ADDENDUM NO. 2
TO
BIDDING AND CONTRACT
REQUIREMENTS AND SPECIFICATIONS
FOR THE
TOWN OF EXETER, NH CONTRACT 4 WWTF LAGOON NO. 1 SLUDGE REMOVAL
WP PROJECT NO. 12883C-C4

TOWN OF EXETER, NH CONTRACT 4 WWTF LAGOON NO. 1 SLUDGE REMOVAL

ADDENDUM NO. 2

WP PROJECT NO. 12883C-C4

EXETER, NEW HAMPSHIRE
 CONTRACT NO. 4
 WASTEWATER TREATMENT FACILITY
 LAGOON 1 SLUDGE REMOVAL
 PROFILES AND DETAILS
DRAWING
 C4-3

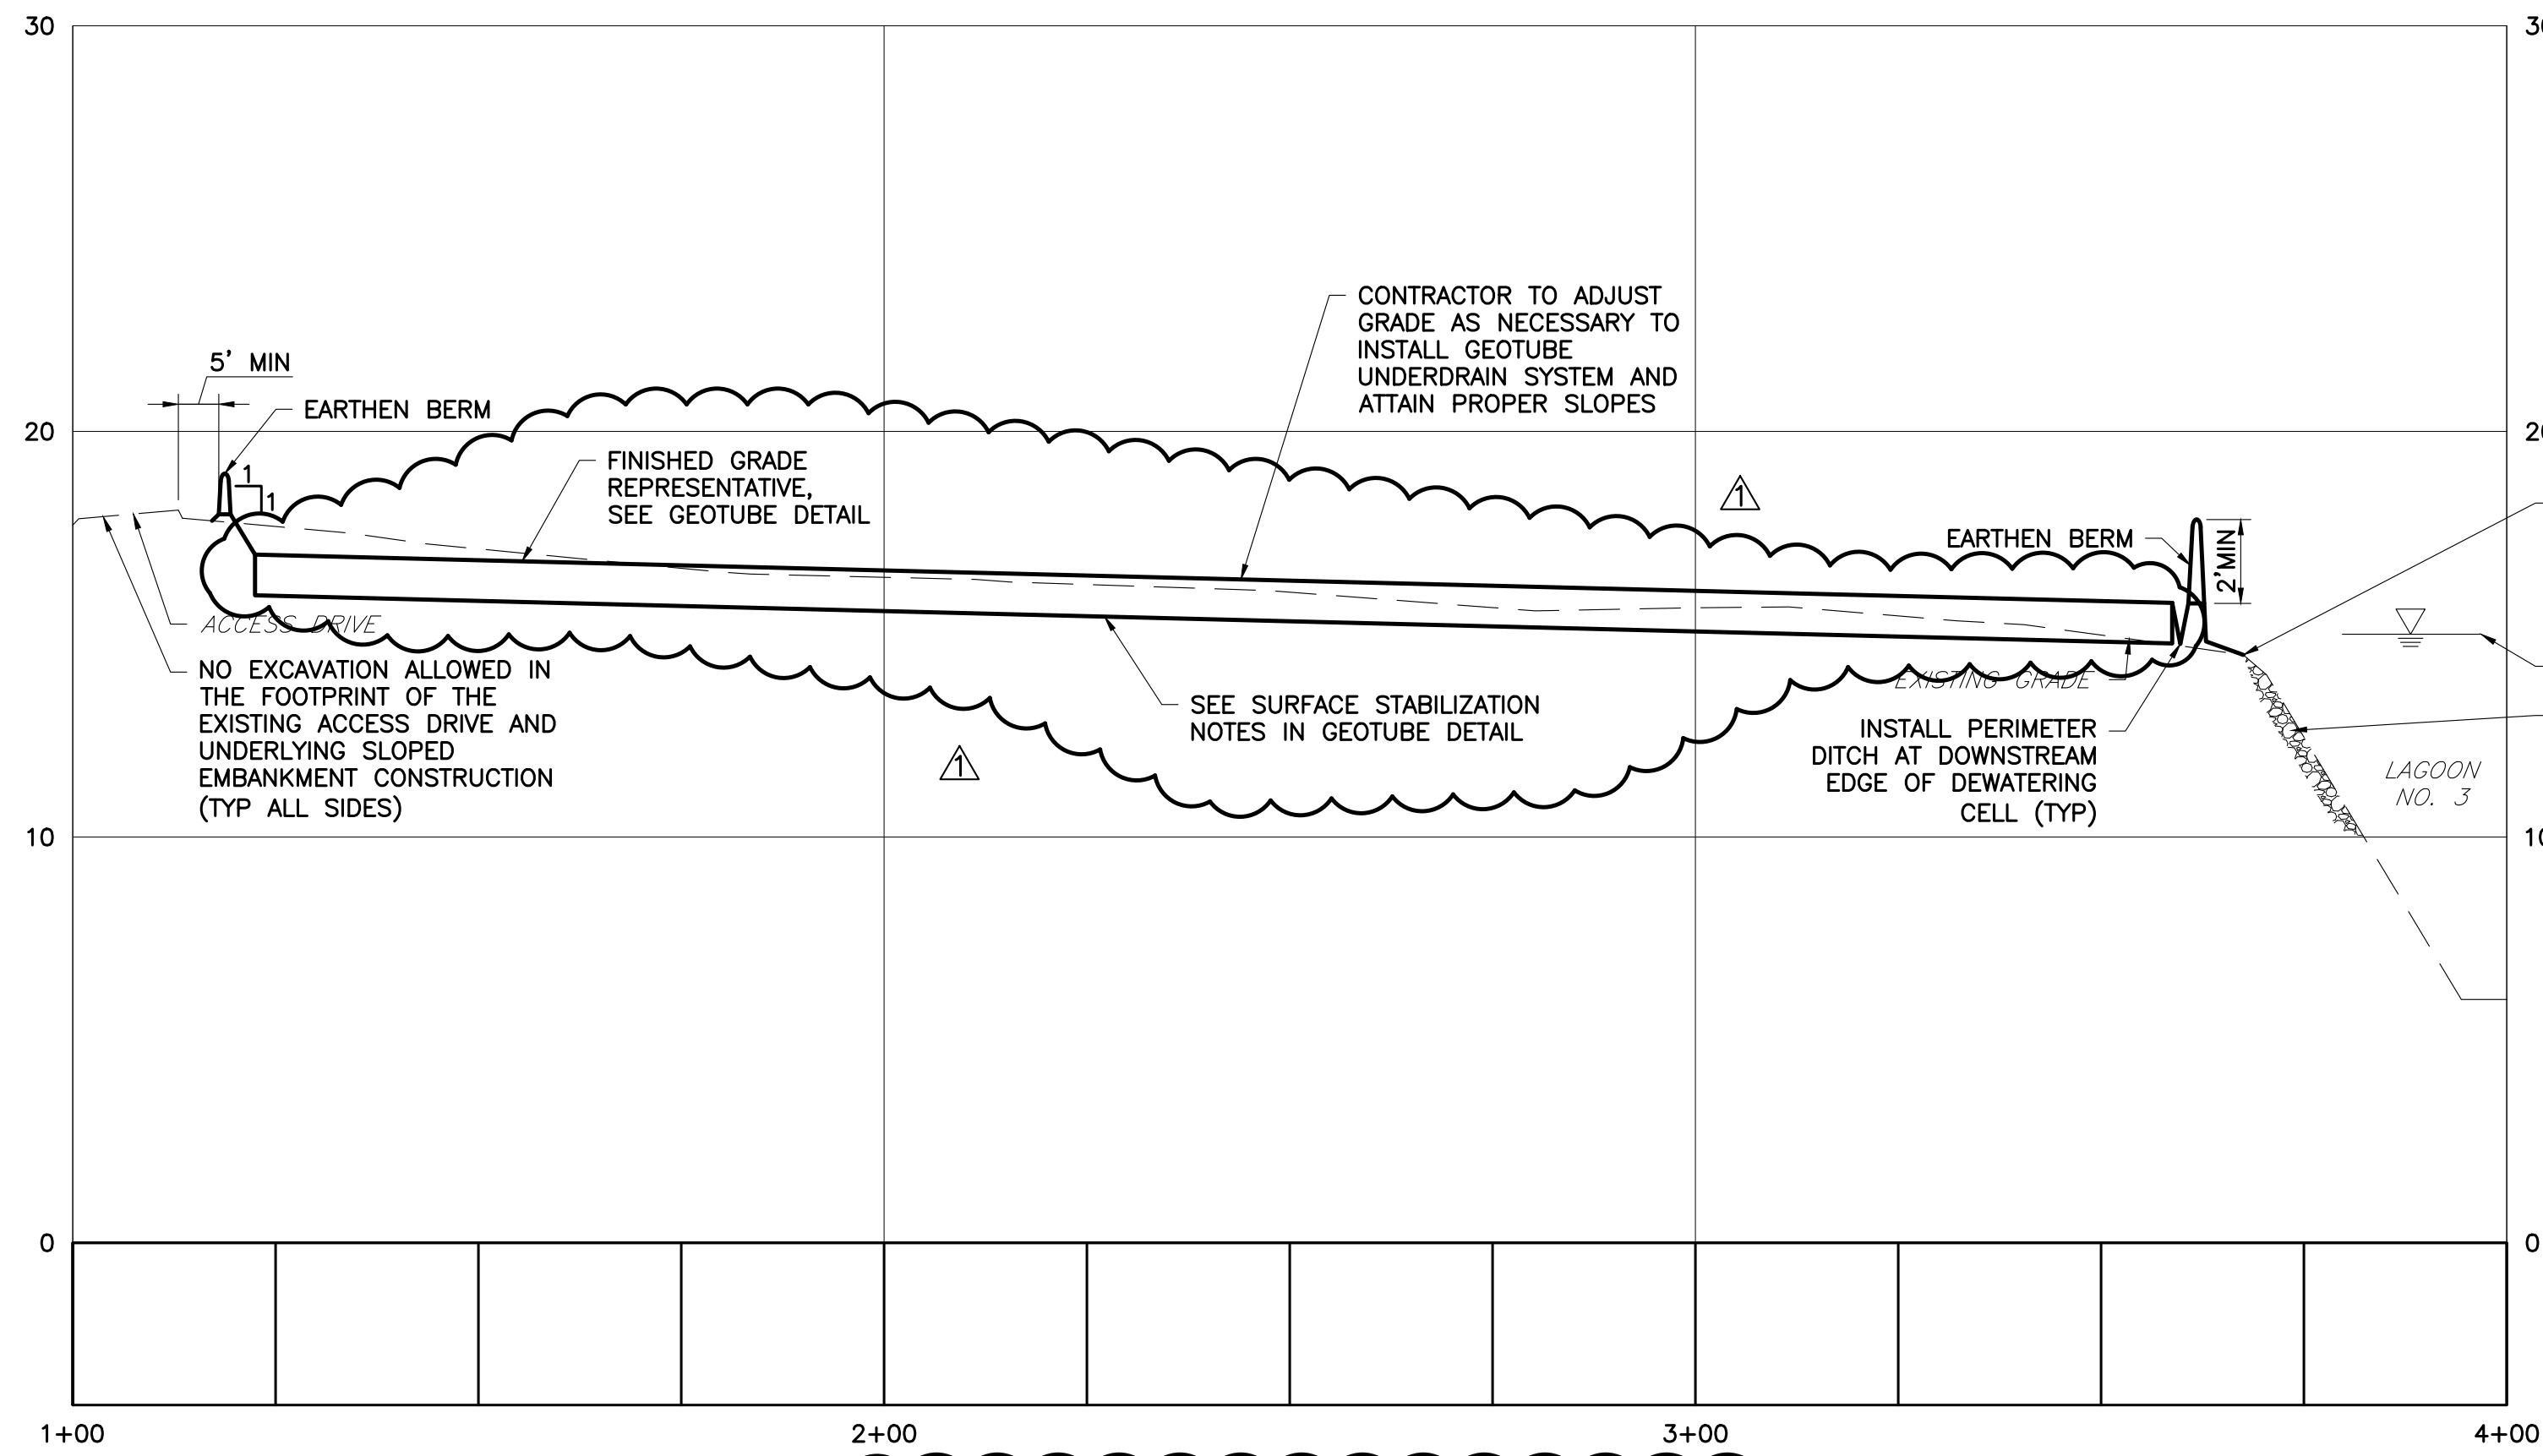
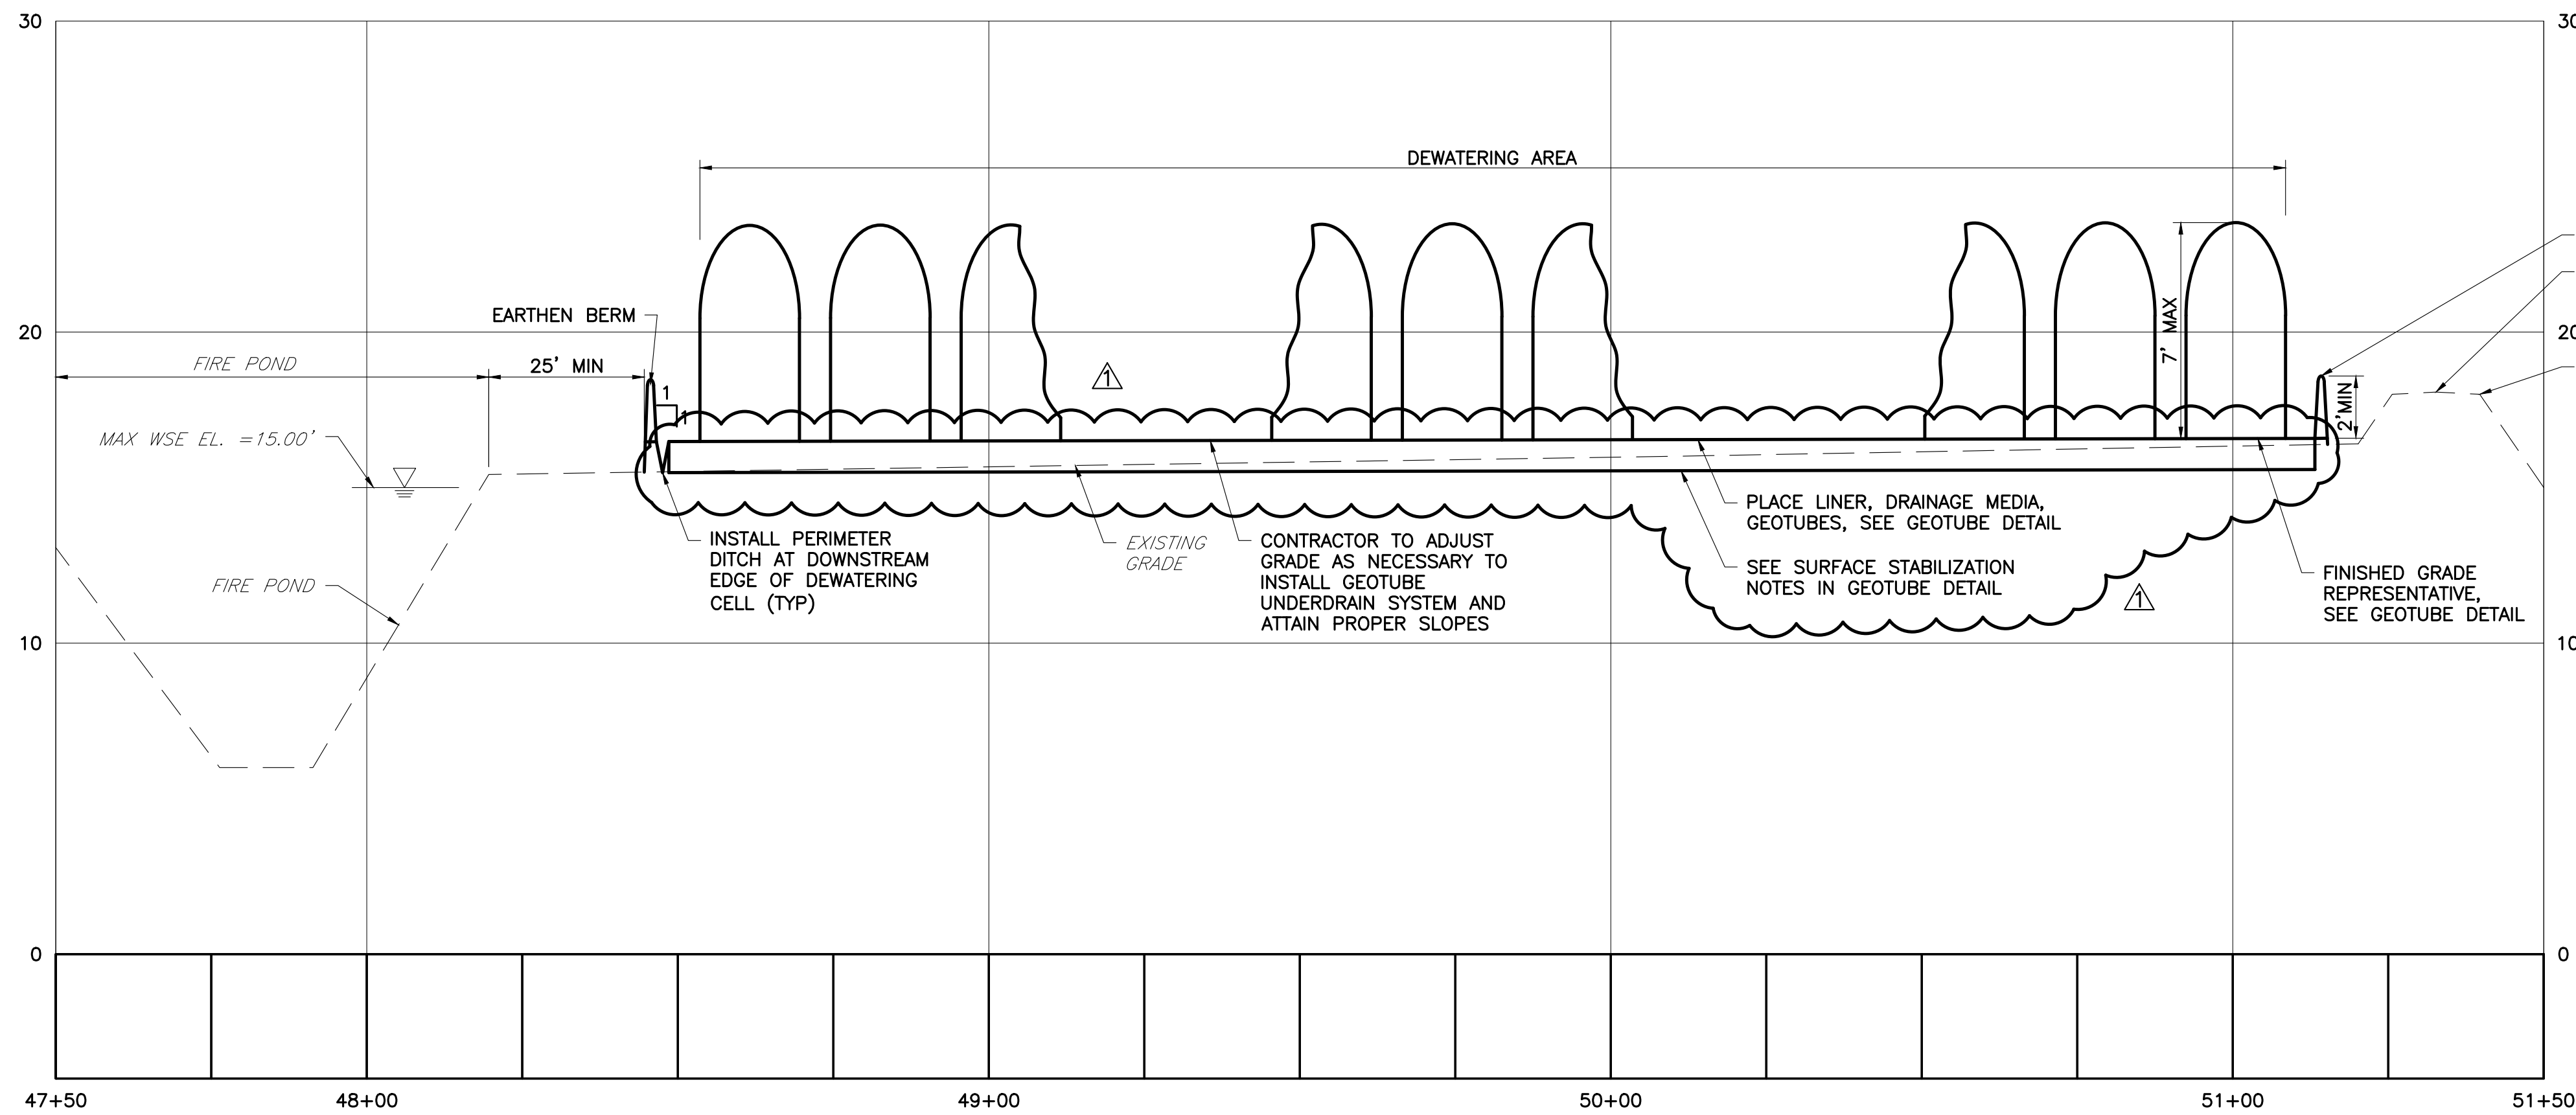
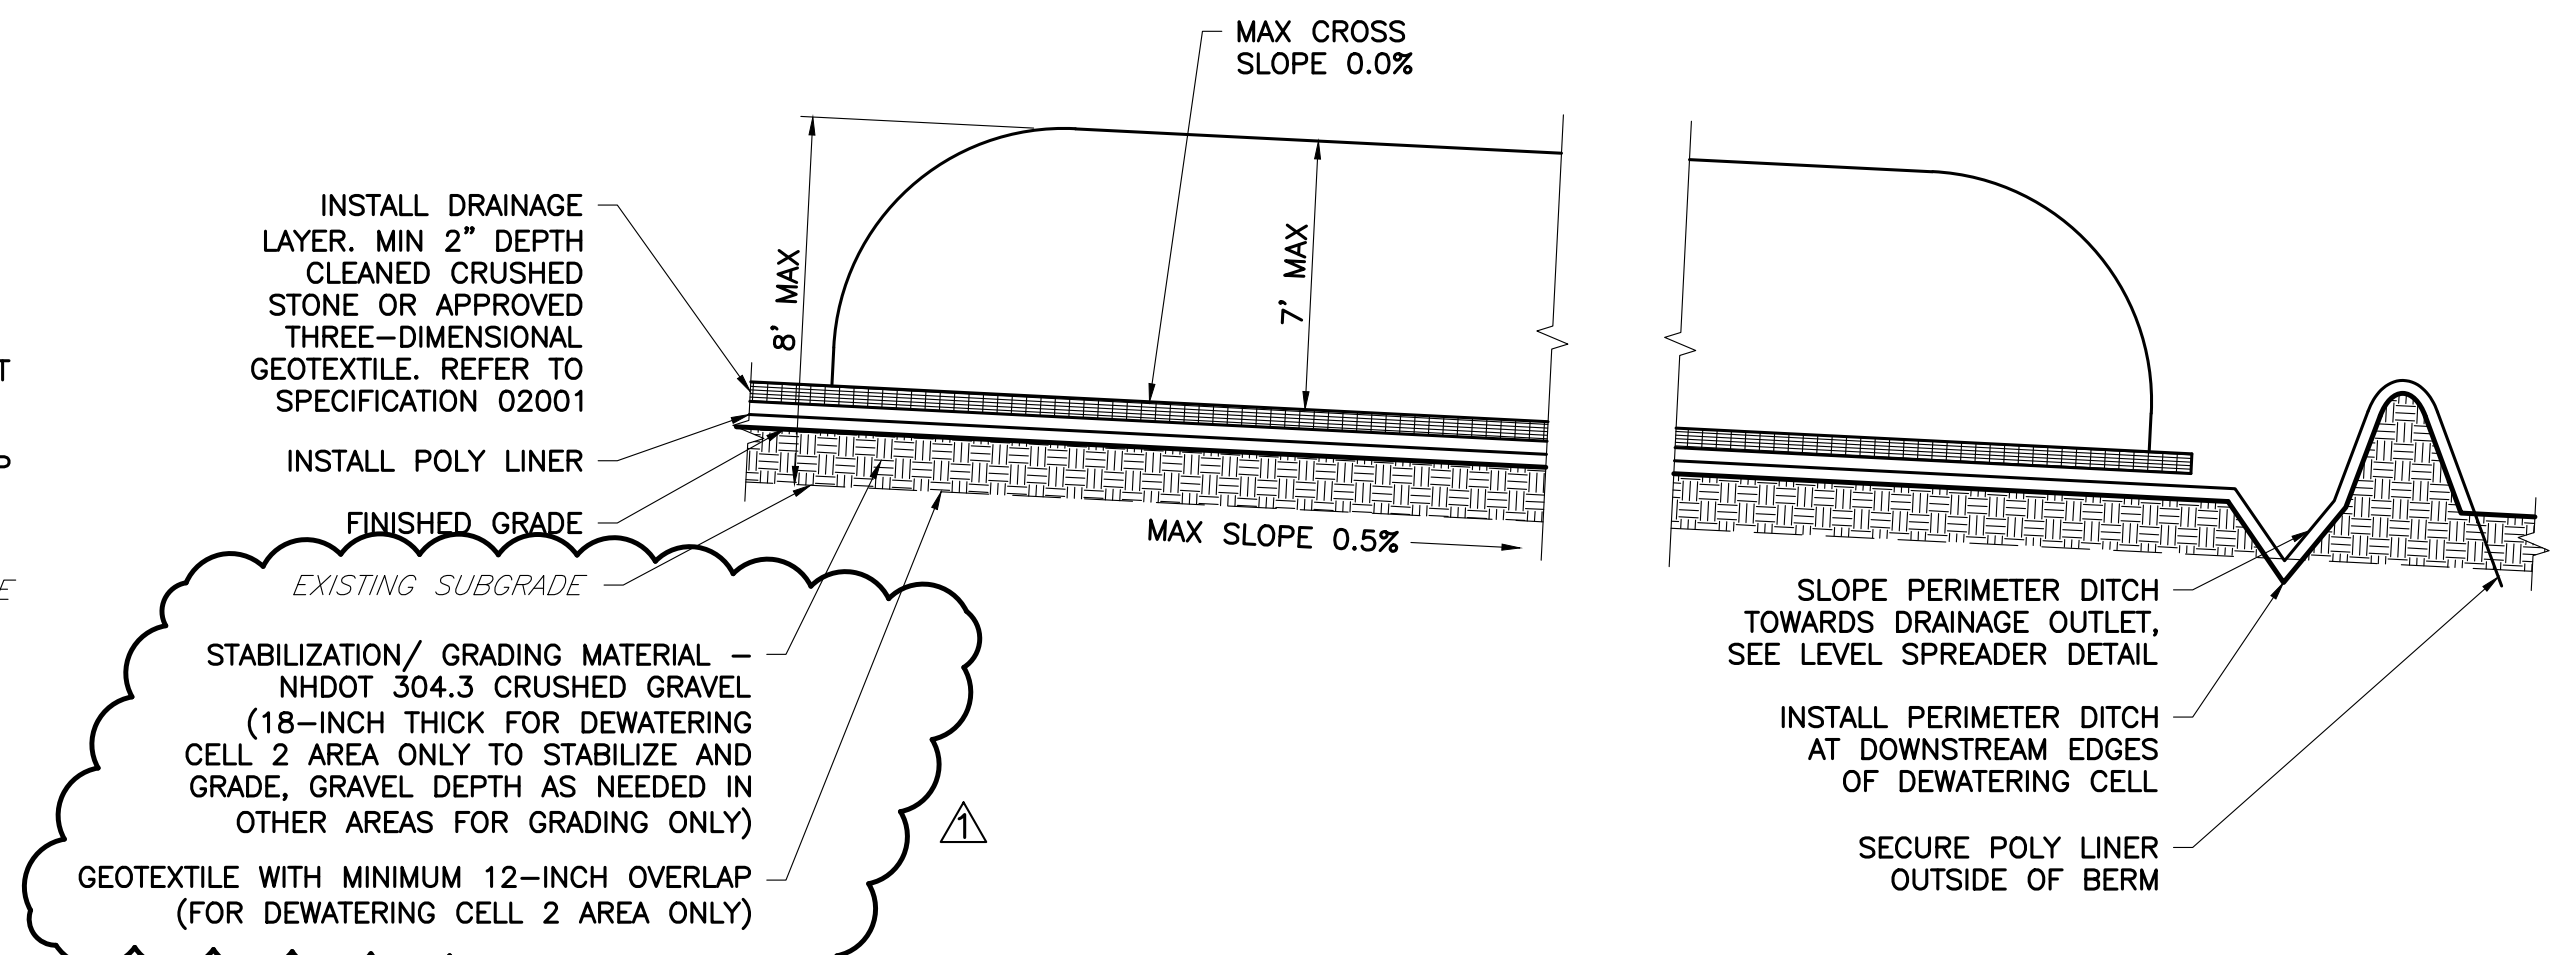
- 2) Dewatering Cell 2 (Lagoon 3 Area) shall be prepared and stabilized prior to placing the poly liner. Refer to the Drawings for details.
 - 3) Dewatering Cell 3 (Materials Storage Area), if used, shall not require surface preparation except as needed to achieve proper slope and to remove anything that may damage the geosynthetic tubes. The cell must include an impervious surface, drainage area, drainage ditch, berm, and sump pump.

Drawing C4-3: **REPLACE** with the attached revised version.
